Re: March 16<sup>th</sup> 2016 Letter – Preliminary Review of Cleco's October 31<sup>st</sup> 2015 CAA 114 ICR Submittal

Cleco Corporation  
Brame Energy Center

## BART Five-Factor Analysis

October 31, 2015, *Revised April 15, 2016*

**Figure 3-1. Refined Meteorological Modeling Domain**

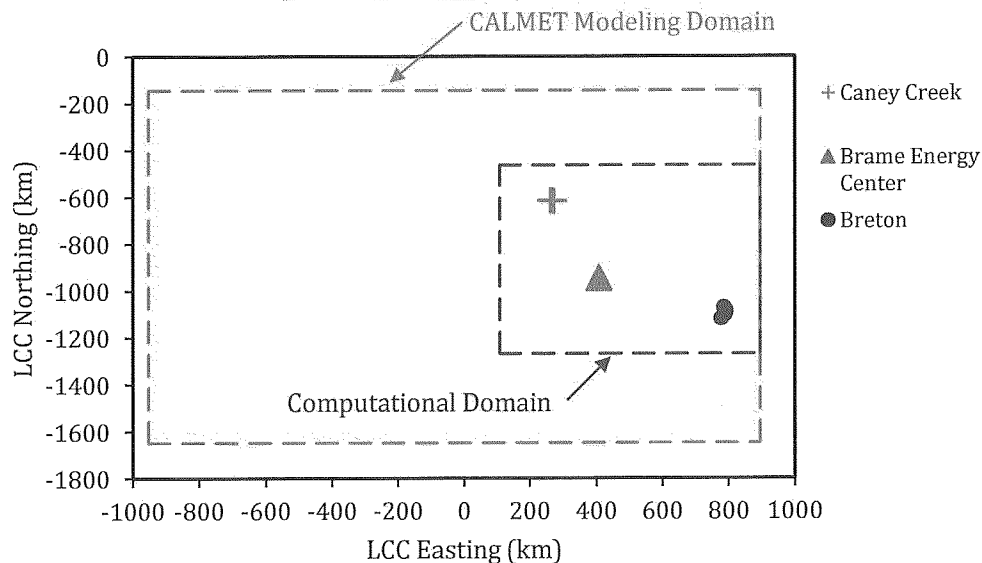
- A. Change of Modeling Computational Grid Domain Size - Between the revised screening modeling and the visibility impact modeling, Cleco reduced the computational domain in order to reduce model run time. The smaller grid was set up such that it extended at least 50 km in all directions beyond Brame 1 and 2 and the Class I areas. This was a deviation from the screening modeling where the computational domain was equal to the meteorological grid. Please rerun the modeling using either the full computational domain to be consistent with the previous screening modeling or a computational domain that extends at least 150 km in all directions beyond Brame 1 and 2 and the Class I areas. As previously discussed, this change is necessary to ensure that emissions that could potentially impact a Class I area do not go out of the grid. The 150 km buffer is consistent with the final modeling protocol that the EPA approved for use by Sid Richardson.***

The CALPUFF modeling submitted in support of the October 31, 2015 BART Five-Factor Analysis is indeed based on a 60 km “buffer” beyond Brame 1, Brame 2, and the Class I area receptors in all directions. The 60 km buffer is designed to account for two things: 1) 50 km buffer to account for recirculation of puffs, and 2) an additional 10 km to account for the

The modeling methodologies and procedures utilized in the October 31, 2015 BART Five-Factor Analysis were followed with one exception: the computational domain was extended such that a 150 km buffer surrounded the modeled sources and Class I receptors. This modeling change was made at the request of EPA in their letter to Cleco regarding their preliminary review of the October 31, 2015 BART Five-Factor Analysis.<sup>7</sup>

Figure 5-1. DSI Performance Curve<sup>18</sup>

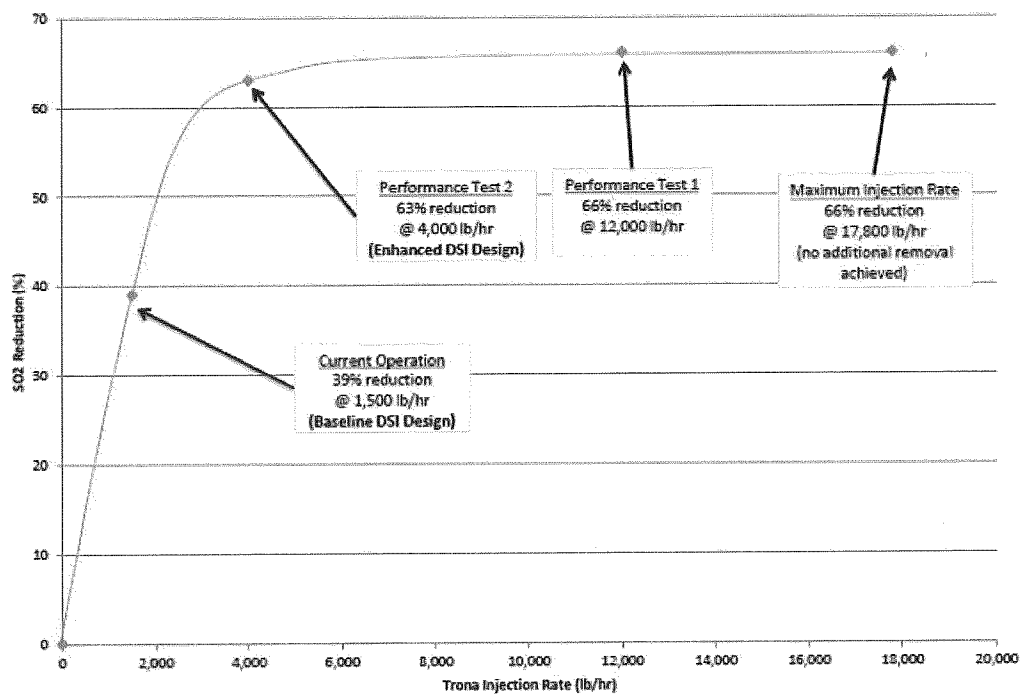
***G. Cost Issue 4 - On page 5-2 of the BART report, Cleco mentions an enhanced DSI performance test that was performed. Please provide any reports associated with this testing.***

The performance test referred to on page 5-2 involved the evaluation of the DSI system for compliance with the MATS HCl limit. Documentation of emissions in that testing only involved HCl. However, the SO<sub>2</sub> CEMS was in operation during the test and provided emission data which Sargent and Lundy used along with the documented trona injection data to complete its evaluation of the effectiveness of the trona system for SO<sub>2</sub> control. There were no reports from the testing referred to on page 5-2 for SO<sub>2</sub> control.
